ADDENDUM NUMBER: ONE (1)

FOR: UAF Jean Tyson CDC HVAC Upgrades
University of Arkansas
Fayetteville, Arkansas
Pettit & Pettit Project #25-120

DATE: August 26, 2026

1 MECHANICAL ROOM NEW WORK PLAN
SCALE: 1/4" = 1'-0"

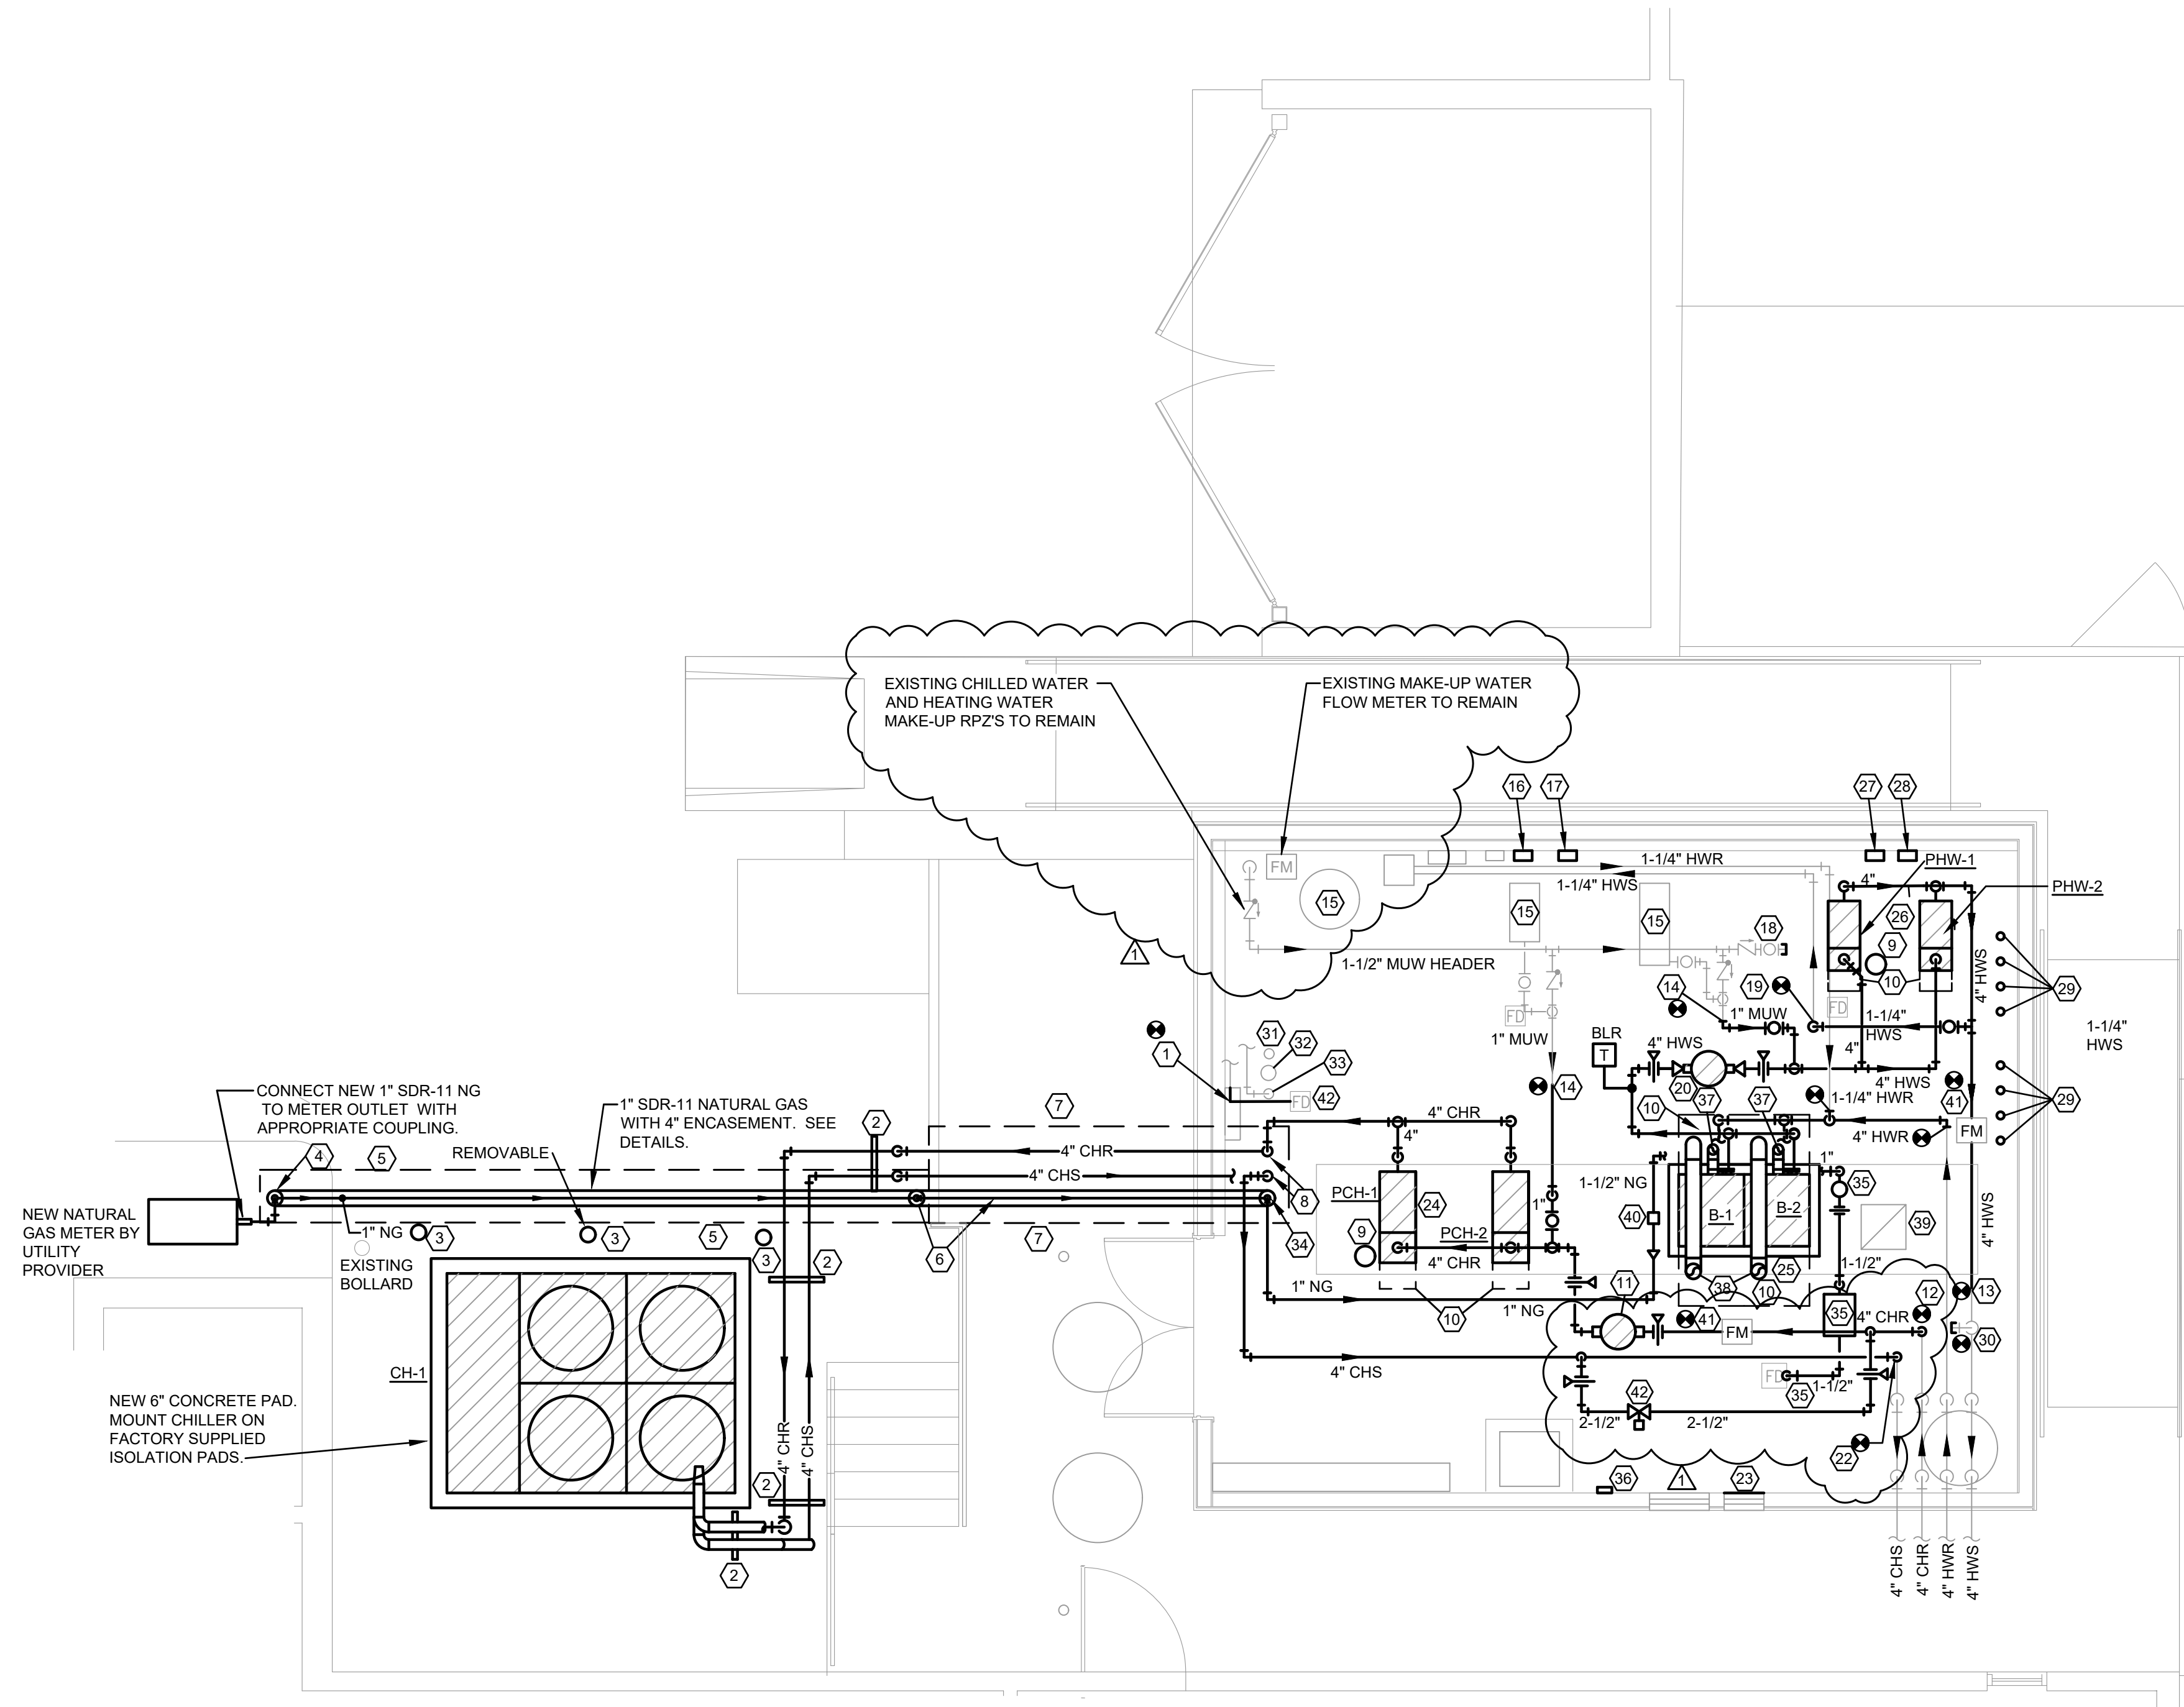
- A1.** REFER TO SHEET T1.0 – ADDED NEW SHEET M1.2 AND E1.2 LISTINGS.
- A2.** REFER TO SHEET M1.1 – REVISED LOCATION OF FLOW METER AND MINIMUM FLOW BYPASS VALVE.
- A3.** REFER TO SHEET M1.2 – ADDED NEW SHEET.
- A4.** REFER TO SHEET M2.1 – REVISED LOCATION OF FLOW METER AND MINIMUM FLOW BYPASS VALVE.
- A5.** REFER TO SHEET M3.0 – REVISED FAN COIL UNIT SCHEDULE.
- A6.** REFER TO SHEET M4.1 – REVISED DETAIL #4 – NATURAL GAS PIPING DETAIL
- A7.** REFER TO SHEET M5.1 – REVISED LOCATION OF FLOW METER AND MINIMUM FLOW BYPASS VALVE.
- A8.** REFER TO SHEET M5.2 – ADDED NOTE ABOUT RELOCATION OF HEATING WATER FLOW METER TRANSMITTER.

- 41 RELOCATE AND INSTALL EXISTING FLOW METER. VERIFY LOCATION OF EXISTING METER.
- 42 CHILLER MINIMUM FLOW BYPASS VALVE.
- 43 RELOCATED FLOOR DRAIN. RECONNECT TO 3" DAIN EXISTING 4" SEWER MAIN.

1 CHILLED WATER SYSTEM - NEW WORK
NTS

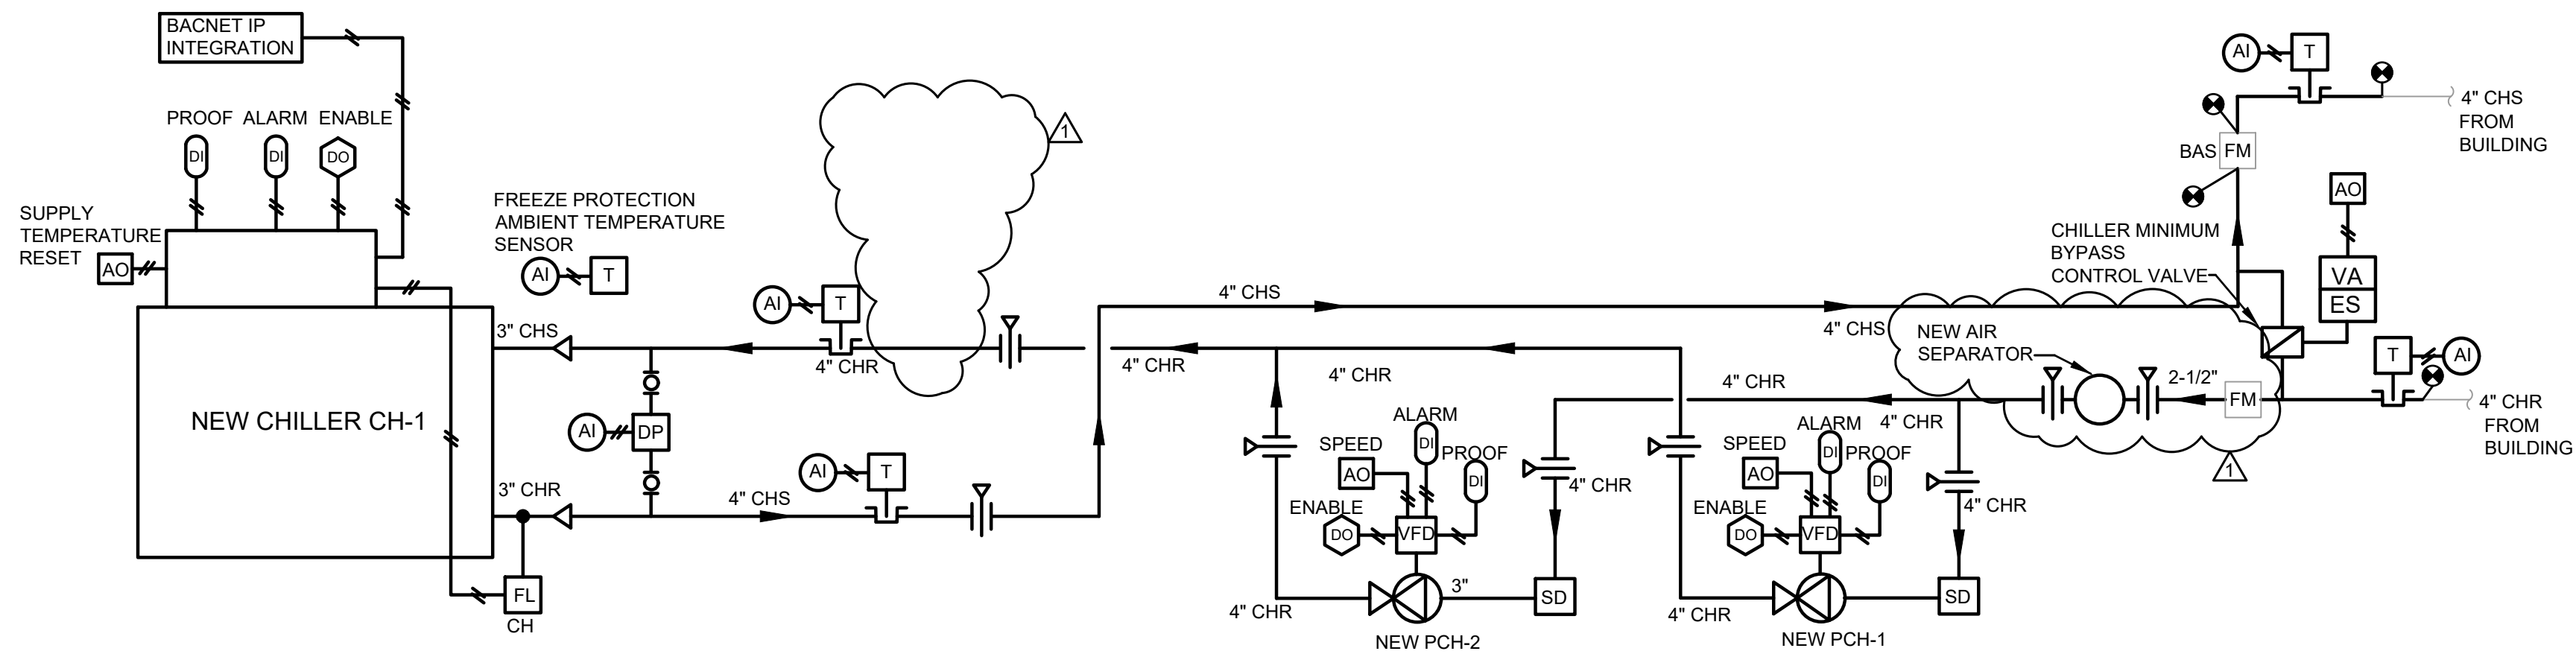
RELOCATE CHILLED WATER EXISTING FLOW METER TRANSMITTER, SEE E1.0.

RELOCATE HEATING WATER EXISTING FLOW METER TRANSMITTER, SEE E1.0.

1 ELECTRICAL ROOM DEMOLITION PLAN
SCALE: 1/4" = 1'-0"

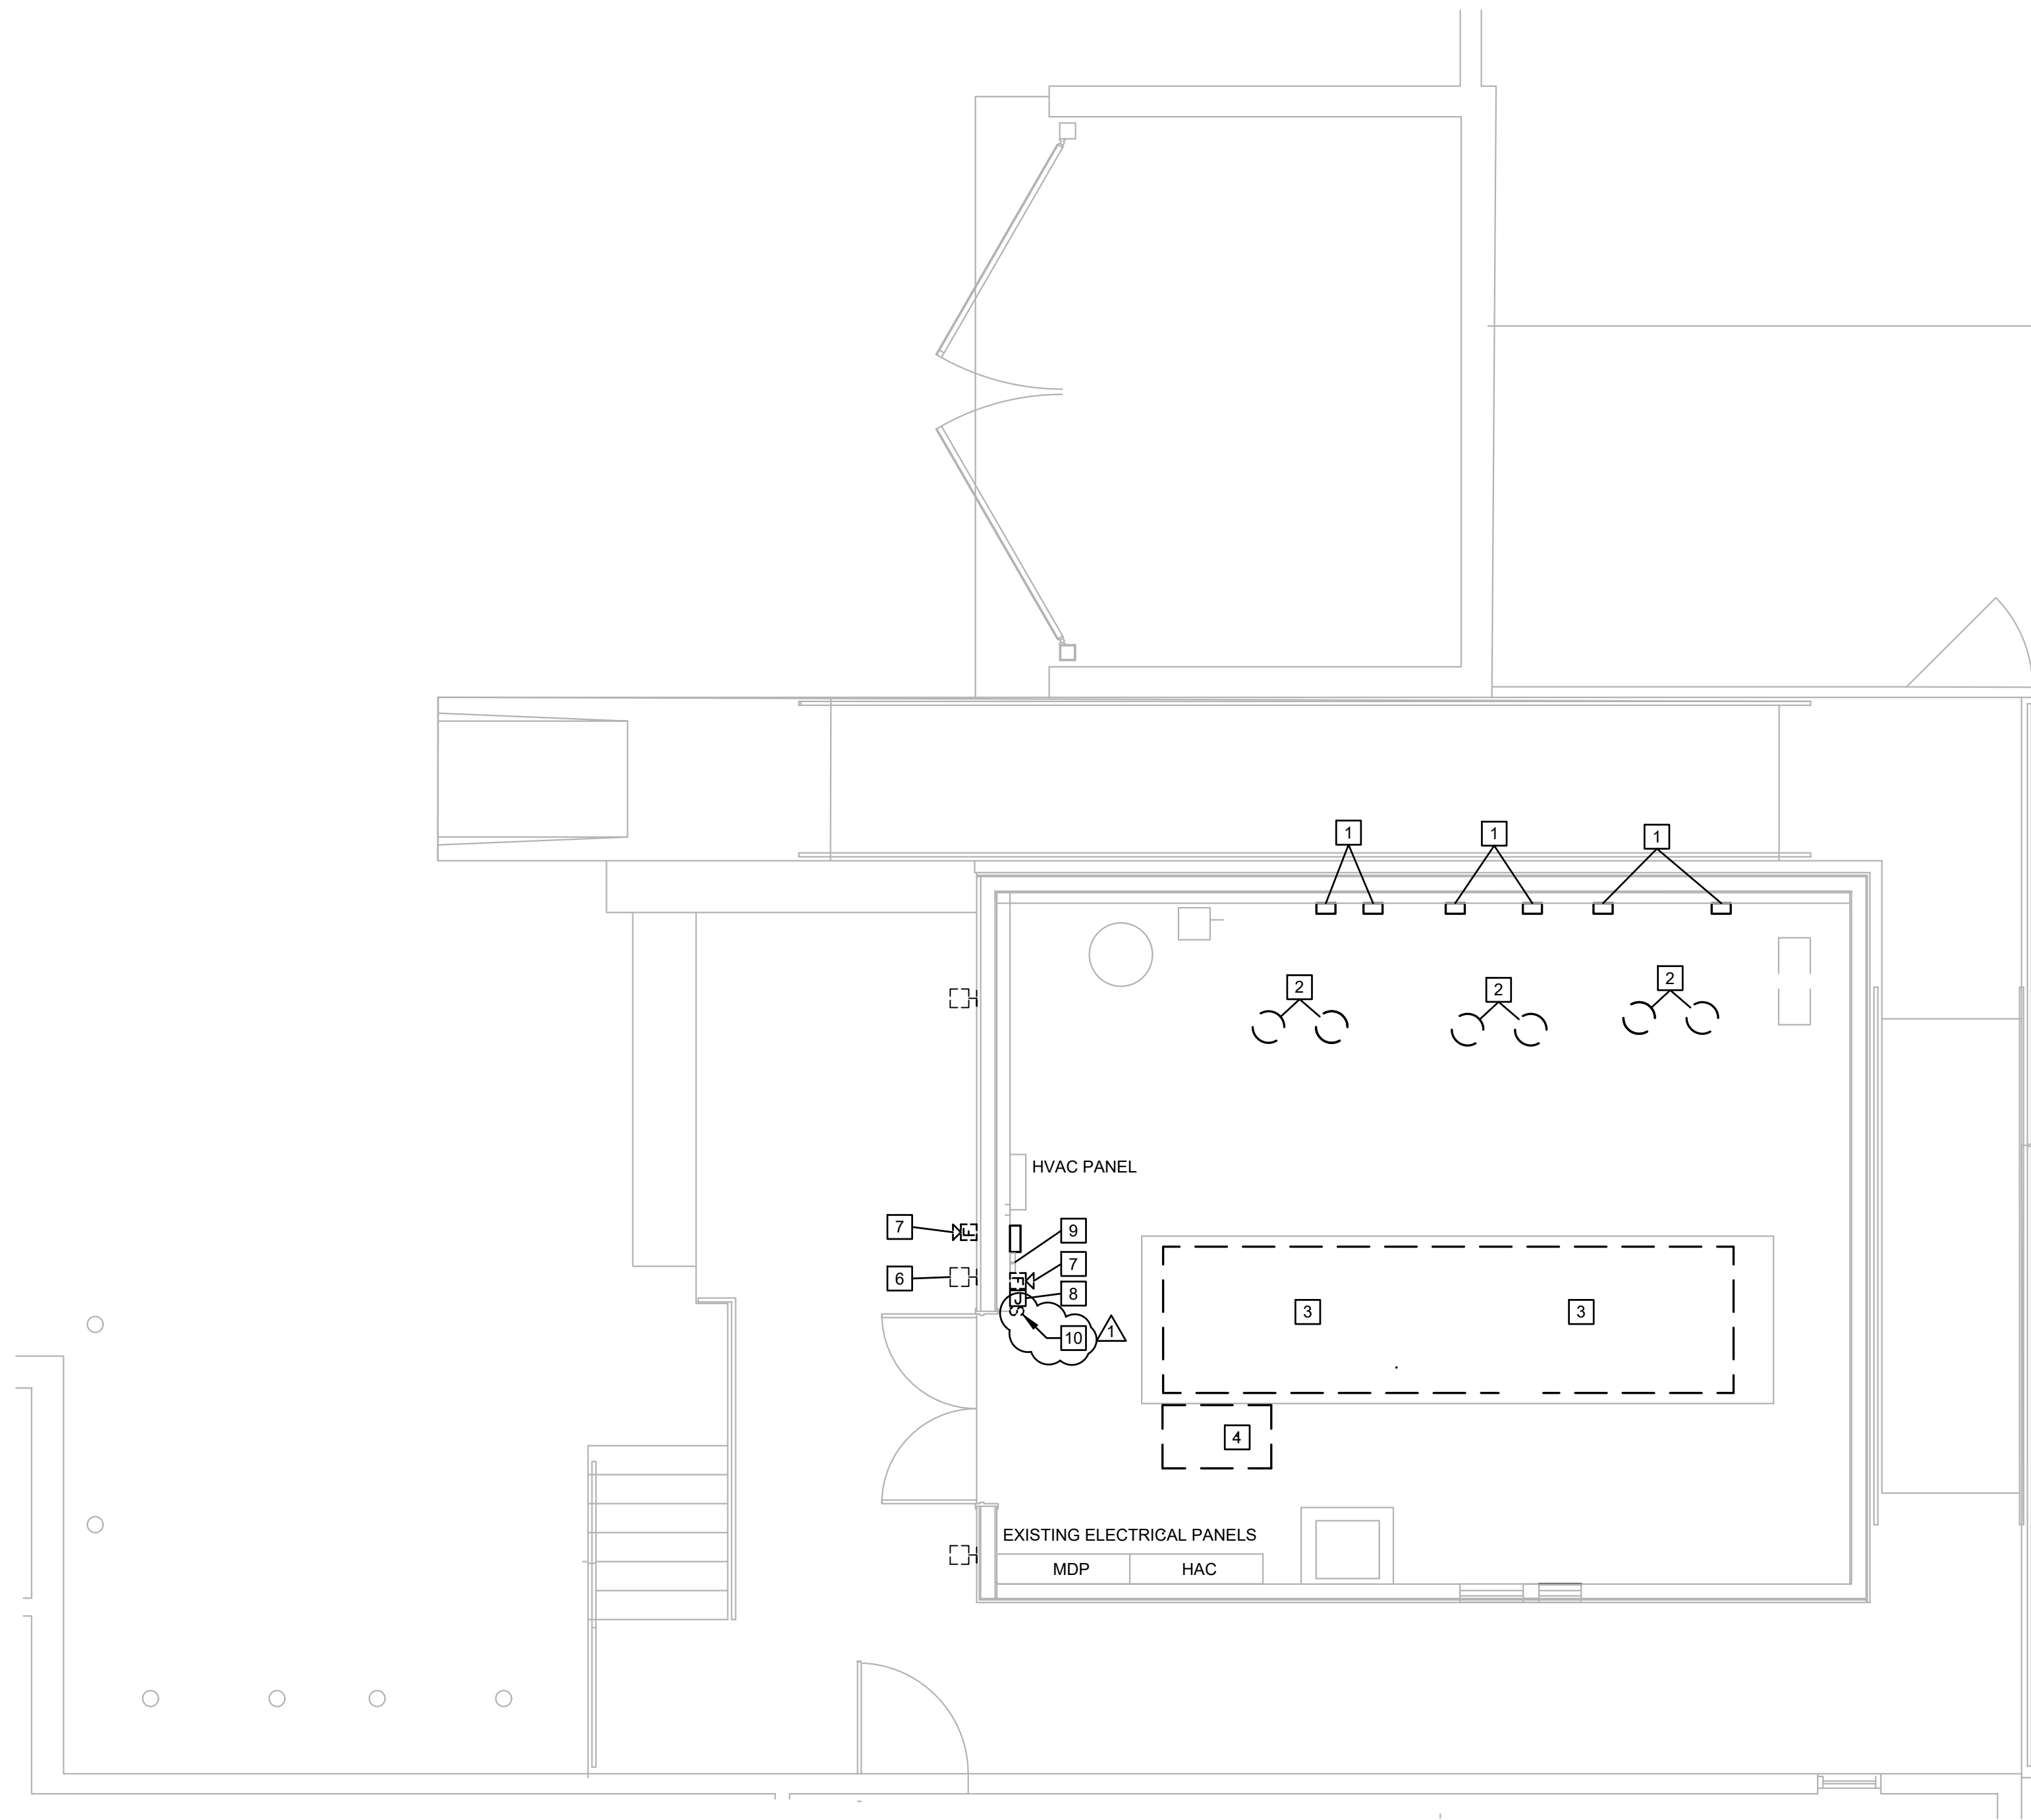
- A9.** REFER TO SHEET E1.0 – ADDED NOTE ABOUT RELOCATION OF THE EXISTING LIGHT SWITCH.
- A10.** REFER TO SHEET E1.1 – ADDED NOTE ABOUT RELOCATION OF THE EXISTING LIGHT SWITCH AND RELOCATED CHILLER AND HEAT TRACE DISCONNECTS.
- A11.** REFER TO SHEET E1.2 – ADDED NEW SHEET.

- 9 MOVE AND RELOCATE THE EXISTING FLOW METERS AS NEEDED TO INSTALL THE NEW PIPING. COORDINATE WITH THE CONTROLS CONTRACTOR.
- 10 RELOCATE EXISTING LIGHT SWITCH.
